DRAINLINE PROFILES

KALANIANAOLE HIGHWAY MEDIAN
IMPROVEMENTS VICINITY OF OLOMANA
GOLF COURSE PROJECT NO. 72A-02-06
SCALE: (H)1"=20', (V)1"=4' DATE: June 2008

SHEET No. C-17 OF 43 SHEETS

DRAINLINE A PROFILE

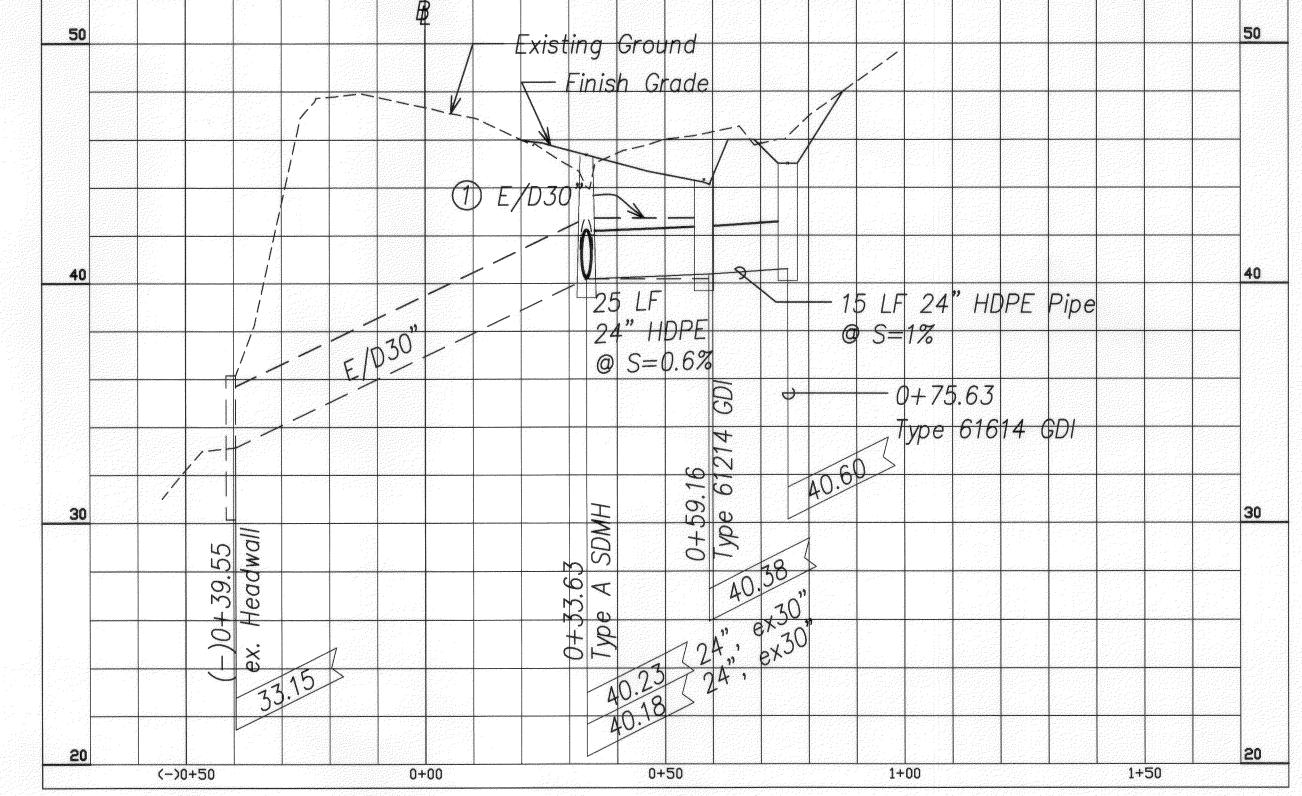
- Connect the existing 30" drain (Waimanalo direction) to new SDMH. Submit shop drawing of connection for approval by the Engineer. This work, including furnishing the 30" connecting pipe and other materials for connection, will not be paid separately and will be considered incidental to the SDMH cost.

Remove ExistingCatch Basin & Pipe
